UNITED STATES PATENT AND TRADEMARK OFFICE

APPLICATION NO.	FILING DATE	FIRST NAMED INVENTOR	ATTORNEY DOCKET NO.	CONFIRMATION NO.
10/707,574	12/22/2003	Gerard H. ROUSSEAU	117424	1573
27074	7590	06/28/2005	EXAMINER	
OLIFF & BERRIDGE, PLC. P.O. BOX 19928 ALEXANDRIA, VA 22320			COLILLA, DANIEL JAMES	
			ART UNIT	PAPER NUMBER
			2854

Office Action Summary

DETAILED ACTION

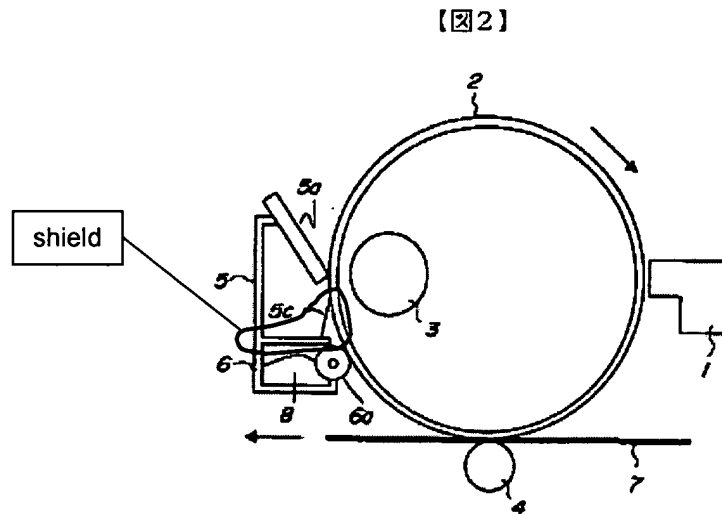
With respect to claim 1, Arai discloses a drum maintenance unit including a casing 5, an oiling roller 5b housed within the casing 5, a metering blade 5a at least partially housed in the casing an spaced from the oiling roller 6a and a shield formed by element 5c and a horizontal portion disposed between the oiling roller and the metering blade 5a as shown below in the Figure taken from Figure 2 of Arai:

With respect to claim 3, the shield forms a physical barrier between the oiling roller 6a and the metering blade 5a as shown above.

With respect to claim 5, as shown above, the horizontal portion of the shield is on contact with the oiling roller 6a at its right end.

With respect to claim 9, the shield partially encases the oiling roller 6a as shown in the above Figure.

With respect to claim 10, the shield generally “L” shape as shown above.

With respect to claim 18, Arai discloses a method for reducing ink transfer to an oiling roller in a drum maintenance unit including the step of providing a shield as shown in the Figure above between the oiling roller 6a and the metering blade 5a.
